Amendments to the Drawings:

REMARKS

This paper is submitted in reply to the Office Action dated April 20, 2005, within the three-month period for response. Reconsideration and allowance of all pending claims are respectfully requested.

FIG. 2

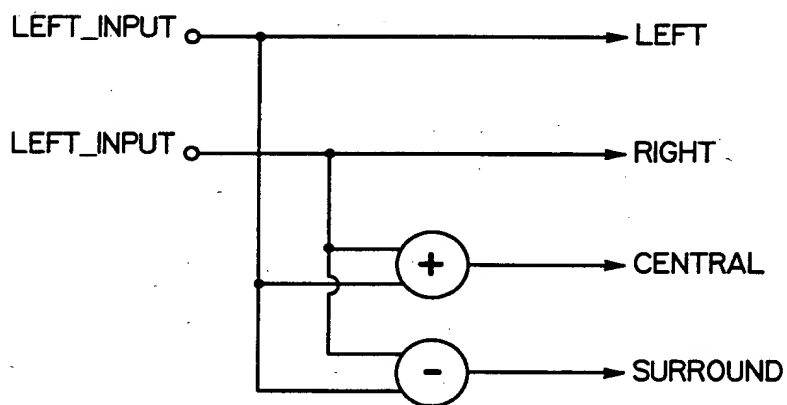
The attached sheet of drawings includes changes to Figs. 1A, 1B and 2. This sheet, which includes Figs. 1A, 1B and 2, replaces the original sheet including Figs. 1A, 1B and 2.

In the subject Office Action, the drawings were objected to under 37 CFR 1.83(a). Furthermore, claims 17-27 were rejected under 35 U.S.C. § 112 second paragraph. Moreover, claims 1 and 5 were rejected under 35 U.S.C. § 102(e) as being anticipated by U.S. Patent Application Publication No. 2004/0120537 to Takei (Takei). In addition, claims 1, 3-4, 6-9, 17-18, 20, 22-24, 26 and 29 were rejected under 35 U.S.C. § 103(a) as being unpatentable over U.S. Patent No. 6,167,140 to Watanabe (Watanabe) in view of U.S. Patent No. 6,760,448 to Gundry (Gundry); claim 2 was rejected under 35 U.S.C. § 103(a) as being unpatentable over Watanabe in view of Gundry and further in view of U.S. Patent No. 6,442,278 to Vaudrey et al. (Vaudrey); claims 10-16, 19, 25 and 28 were rejected under 35 U.S.C. § 103(a) as being unpatentable over Watanabe in view Gundry and further in view of U.S. Patent No. 6,766,028 to Dickens (Dickens); and claim 27 was rejected under 35 U.S.C. § 103(a) as being unpatentable over U.S. Patent No. 6,167,140 to Watanabe in view of Gundry and further in view of Takei.
